**Re:** DART+ West Railway Order - Dublin City to Maynooth and M3 Parkway  
County Dublin, County Meath, County Kildare

**RE: SUBMISSION ON DART+ WEST RAILWAY ORDER – DUBLIN CITY TO MAYNOOTH AND M3 PARKWAY IN RELATION TO PROPOSED WORKS AROUND ASHTOWN GATE COMPLEX, ASHTOWN**

**AN BORD PLEANALA REFERENCE NUMBER: 314232**

**Figure 2- Proposed Access onto Local Distributor Road from Ashtown Gate Complex**

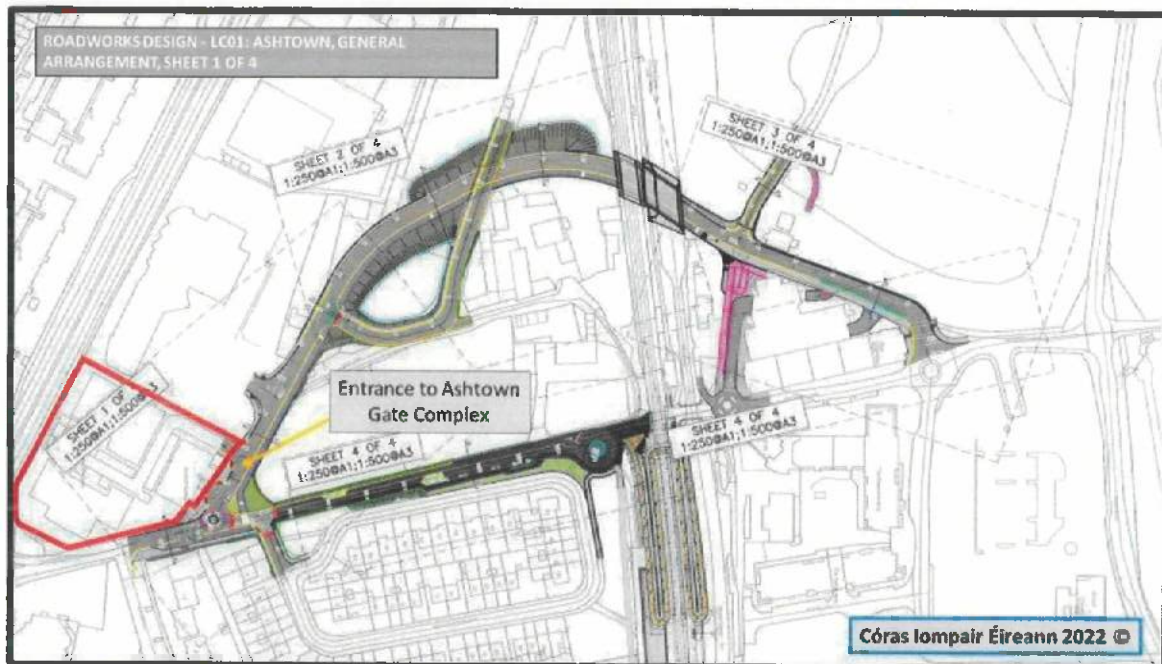
2.5 The proposed works are considered to have the potential for disruption to Aviva's tenants using the car park facility on a daily basis.

- 3.3 The revised junction layout proposes direct access from the rear entrances of the Ashtown Gate Complex, thus making it more challenging for tenants/users to leave the property without the benefit of a signalised junction for easy access and egress.
- 3.4 Additionally, there are no yellow boxes indicated on the drawings as seen in the figure below, raising safety concerns for Aviva and their tenants.

- 3.6 The reality is that the entrance to Ashtown Gate is very close to the junction, and the proposed upgrade to the road will materially increase traffic volumes on the road. With the provision of a yellow box in front of both entrances, it will allow for easier and safer entry & exit to the complex, in turn providing greater reassurance to Aviva and its tenants when the programme of works has been completed.

**Figure 5- Proposed Pedestrian Crossing Location**

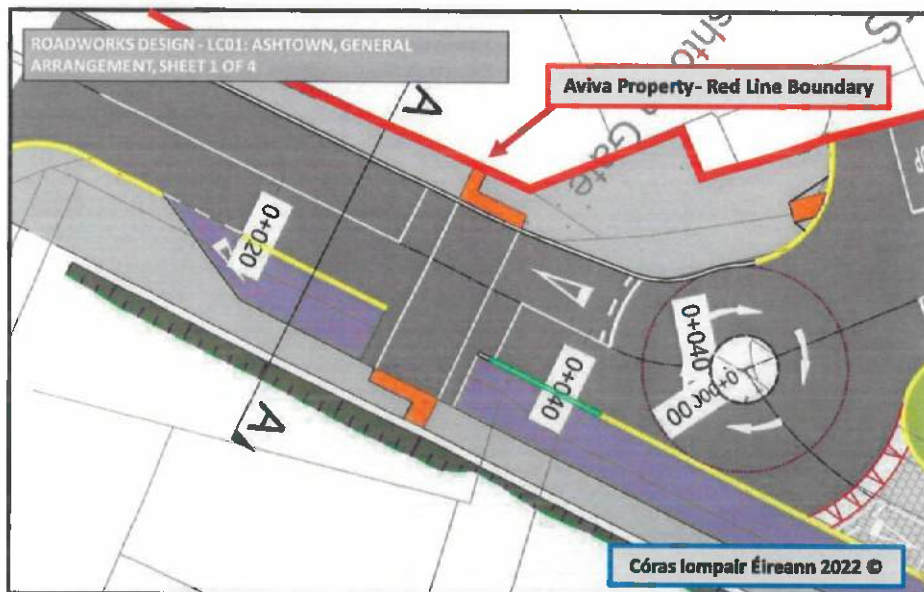
- 3.14 We would note however that the location of the pedestrian crossing may introduce issues with its interaction to the road users, as the existing straight road section connecting to the Ashtown Station is proposed to be replaced with a small roundabout which offers pedestrians no real protection from speeding vehicles around corners.

- 3.16 This can only be achieved in a safe manner with the guarantee that all measures have been taken to ensure speed limits are not exceeded by motorists, and blind spots are well covered to prevent any major accidents, particularly for oversized and blind spot prone vehicles.

- 3.17 It is submitted that a review of the submitted design proposals should be considered, with particular attention given to the interaction of road vehicles with pedestrian and cyclist infrastructure, as Aviva believes there is potential for serious accidents if not addressed.
